Environmental Review Team Report

Cadoret Subdivision

Canterbury, Connecticut

April 1984

Drainage Areas

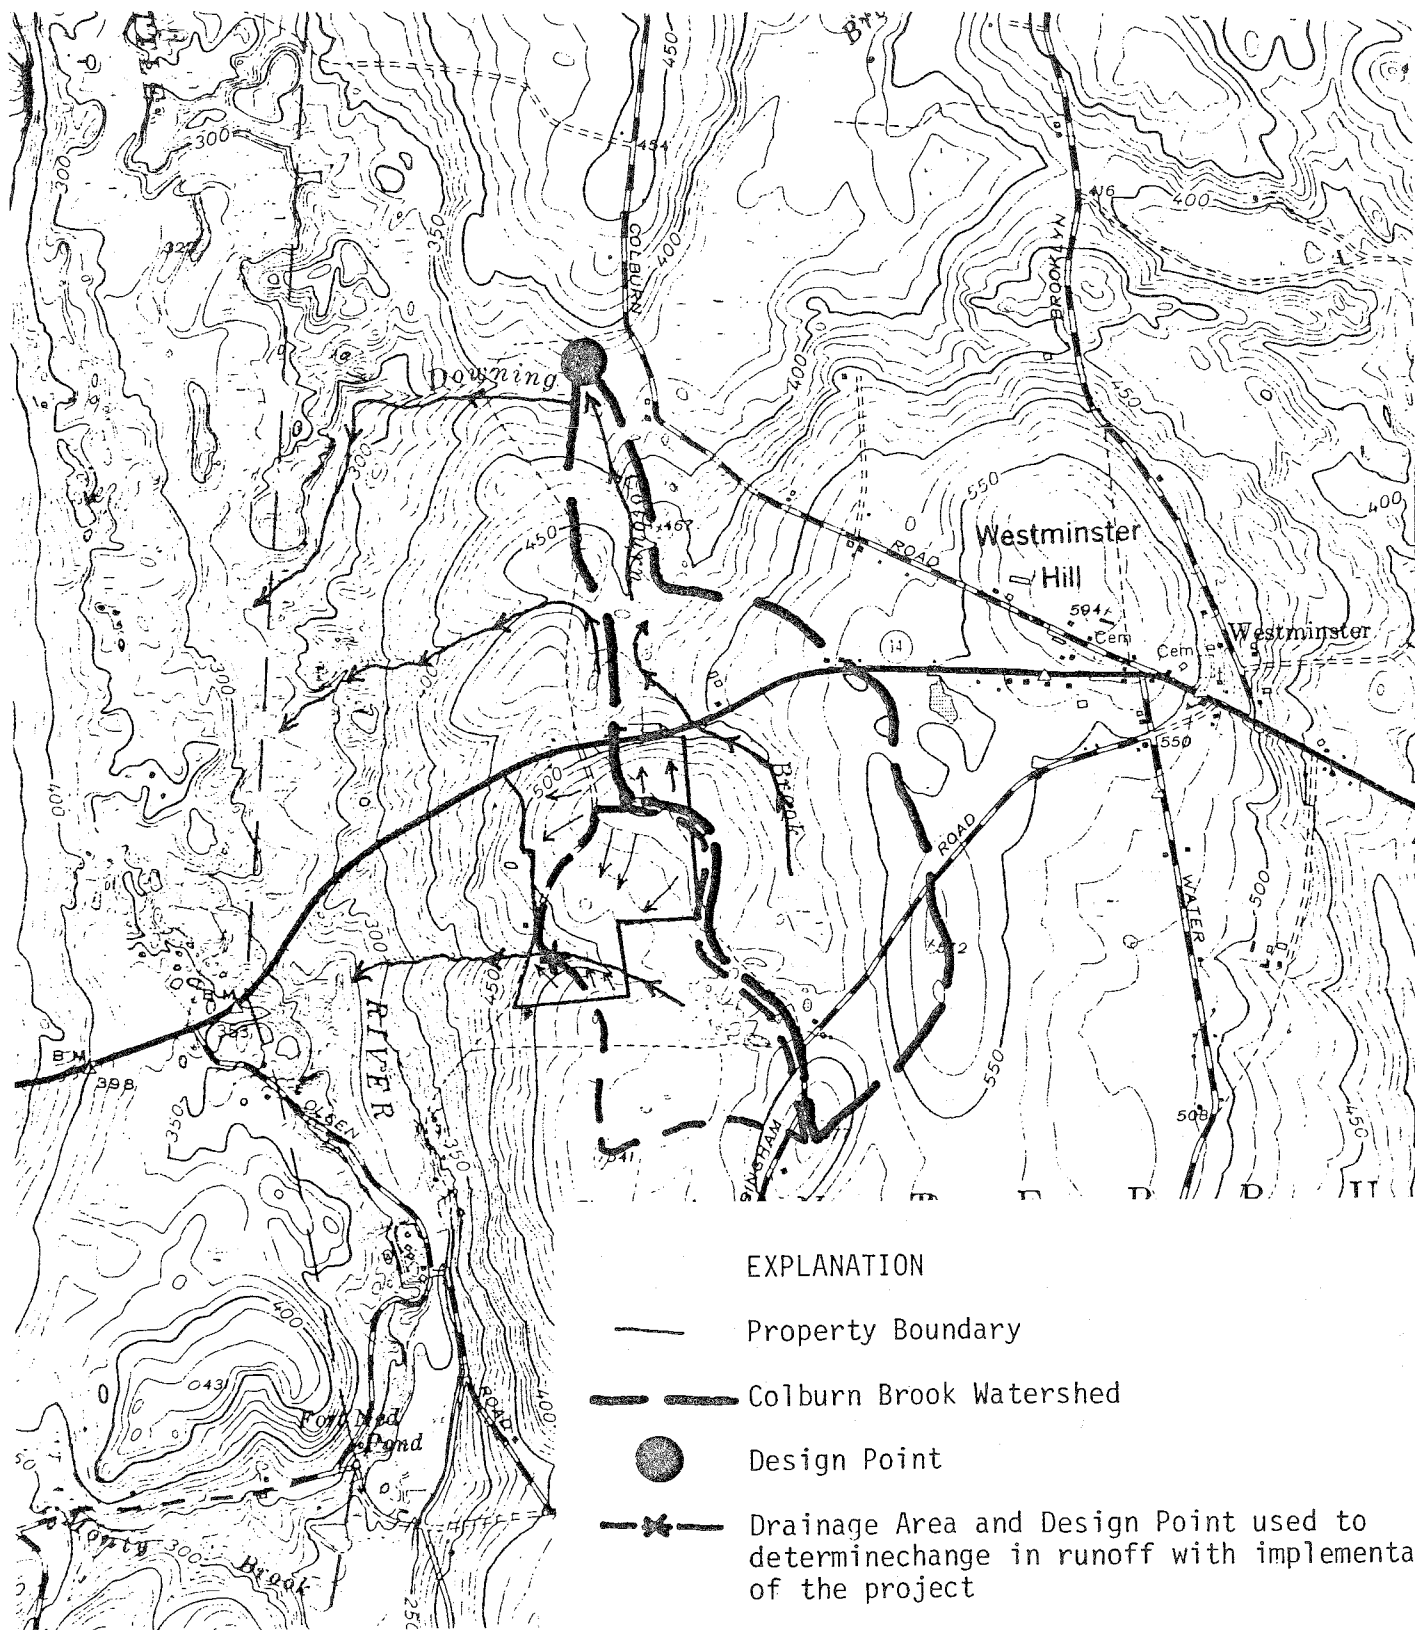
The site plans distributed to Team members the day of the field review was not, by itself, sufficient to allow the determination of the effects from storm sewerage. Nevertheless, an estimate can be made of the runoff changes likely to occur as a result of this land use modification proposed for the site. A simplification of Technical Release No. 55 of the Soil Conservation Service provides a technique which may be used in formulating runoff estimates. This method involves the determination of runoff curve numbers, which relate the amount of precipitation to amounts of runoff. Because nearly 75 percent of the proposed homes (22) to be constructed lie within the watershed, which drains the central and southern portions of the property, the following runoff estimates shown in the following table refer only to this portion of the site. It was assumed that stormwater drainage in this area would be artificially collected in a stormwater system along the access roads and outletted at a point east of the temporary cul-de-sac. The construction of residential homes on Lots 1 and 24-30 should have little or no effect on runoff increase in their respective drainage areas. However, the applicant's project engineer should check the adequacy of the culvert passing under Route 14 (west of

The results of the runoff calculations performed by the Team's geohydrologist for the designated area are shown in the accompanying table. It should be noted that these runoff amounts are only estimates and should not be used as exact data for any engineering purposes.

As indicated by the accompanying table, it is estimated that the proposed development in the central and southern portion which includes Lots 2-23 would increase the curve number of the site by 1 (62 to 63). Under these conditions, runoff depth for a 25-year storm event would increase from 1.74 inches to 1.83 inches; an increase of about 5 percent. While the impact of the proposed development in the area mentioned above may be small, the cumulative impact of unregulated runoff from future development in the drainage area may be severe.

Because much of the runoff from the site takes the form of sheet flow and because slopes are moderate in some areas, the potential for erosion should be of concern. For this reason, it is recommended that a comprehensive erosion/sediment control plan be developed covering each phase of the proposed development.

Erosion and sediment control measures should be shown on the subdivision site plan. Considerations should be given for the installation of a temporary sediment pool during the construction phases. The pond could be located east of the temporary cul-de-sac on Goodwin Road #2. If the sediment pool is constructed, it should be located on upland type soils rather than wetland soils, i.e., Rn (Ridgebury, Leicester, Whitman soils). This will minimize wetland disturbance.

Vegetation

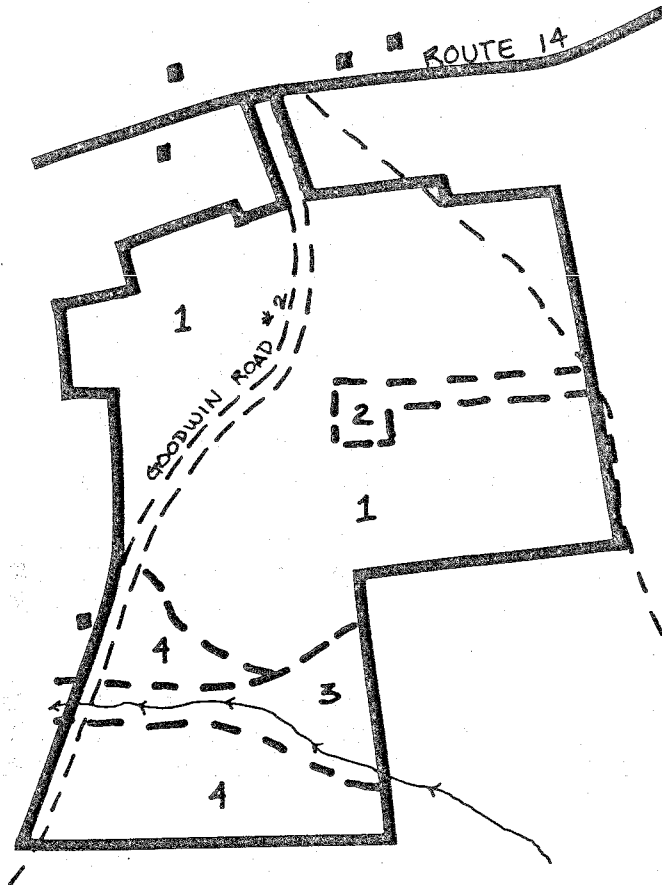
Trees are very sensitive to the condition of the soil within the entire area under their crowns. Development practices near trees, such as excavating, filling and grading for construction of roadways and buildings may disturb the balance between soil aeration, soil moisture level and soil composition. These disturbances may cause a decline in tree health and vigor, potentially resulting in tree mortality within three to five years. Mechanical injury to trees may cause the same results. Dead trees reduce the aesthetic quality of an area and may become hazardous and expensive to remove if near roadways, buildings or utility lines.

Care should be taken during the construction period not to disturb the trees that are to be retained. In general, healthy and vigorous trees should be retained as they are more resistant to the environmental stresses brought about by construction.

Where feasible, trees should be saved in small groups or "islands." This practice lowers the possibility of soil disturbance and mechanical injury. Individual trees and "islands" of trees should be temporarily, but clearly, marked so that they may be avoided during construction.

The poorly drained soils present within Vegetation Type 3 (Hardwood swamp/streambelt) limit the vegetative growth to species that are able to tolerate high moisture conditions. The sugar maple, white birch and yellow birch are able to tolerate the present site conditions, however, any adverse change in the drainage condition could change the species composition of the area.

The loss of trees due to windthrow is a potential hazard in Type 3. The soil is saturated with water for the greater part of the year causing soil aeration to be poor. These conditions result in unstable, shallow root systems which are unable to securely anchor the trees. The potential for windthrow is intensified by the crowded condition in the hardwood swamp. It should be noted that any clearings made in and around this area will increase the windthrow hazard by allowing the wind to pass through rather than over this area. If possible, any clearing of vegetation in this type should be kept to a minimum.

The trees which are present in Vegetation Types 1 and 2 are declining in health and vigor as a result of past fires, gypsy moth infestations and droughty site conditions. Long term management of these Vegetation Types should be aimed at conversion to softwoods. Softwoods are preferred on dry sites because, unlike

hardwoods, their growth is completed before the occurrence of a late summer drought. In Type 1, 1/3 of the total fuelwood volume may be removed, prior to underplanting softwoods. Either white pine or hemlock will do well on these sites as evidenced by the growth of those present in Type 2. The softwoods should be planted on a 15'x15' spacing, however, if any openings are created, the softwoods may be planted 8'x8'.

Ten years after the first cut, another third of the fuelwood volume should be removed. Removal of the overstory should be completed 20 years after the first cutting.

One half of the total fuelwood volume in Type 2 should be removed to release the pines and hemlocks to allow increased growth. The remainder of the overstory should be removed ten years after the first cut.

Vegetation Type 3 could be lightly thinned by removing 1/4 of the total fuelwood volume. The sugar maple, white ash and yellow birch should be favored for the residual stand. Care should be taken not to create any large openings in the crown canopy.

To avoid irreversible soil damage, thinning operations in the hardwood swamp/streambelt should be implemented during the winter months when the ground is frozen or the summer months when the ground is dry.

Vegetation Type 4 should be left as is and reevaluated in ten years.

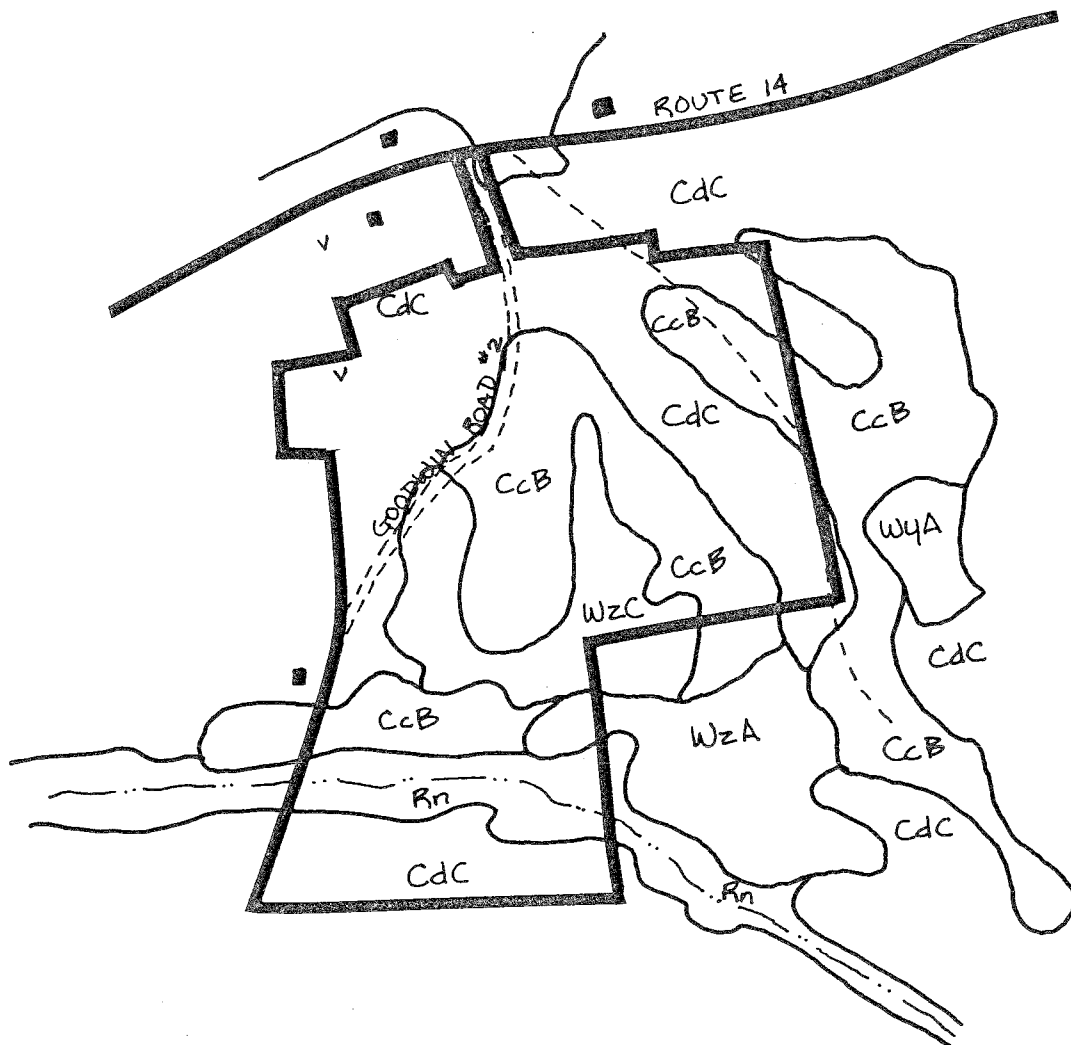
The vertical curve with PVI at sta. 7+00 has a grade difference of 7% (5%-(-2%)). From the American Association of State Highway and Transportation Officials (AASHTO) A Policy on Geometric Design of Rural Highways the minimum length of vertical curve for a 7% grade difference and a design speed of 30 MPH is 200 feet. The plan of the proposed road shows a vertical curve of 150 feet.

Catch basin No. 1 on the easterly side of Goodwin Road #2 and adjacent to State Route 14 is shown with a rim elevation approximately equal to the centerline grade of Route 14. This rim should be lowered to an elevation slightly below the edge of pavement of Route 14 in order to collect the maximum amount of water shed from the state road and prevent flow across the end of Goodwin Road #2.

The existing cross culvert in Route 14 to which the street drainage from the northerly portion of the project is to be directed is severely plugged with sediment and does not have a well defined drainage channel leading away from its outlet. Arrangements must be made with the state to clean this culvert and channel water to an appropriate discharge point before any additional flow is added.

Consideration should be given to make catch basin No. 9 at sta. 12+30 a type C-L and locate it in such a way as to make it possible to change the top to a type C and have it become part of the continuation of the Goodwin Road #2 improvement when the next phase is undertaken.

If the portion of Goodwin Road #2 which is not to be improved under this phase is to remain passable, then suitable provision should be made at the cul-de-sac to allow traffic to continue onto the unimproved section.
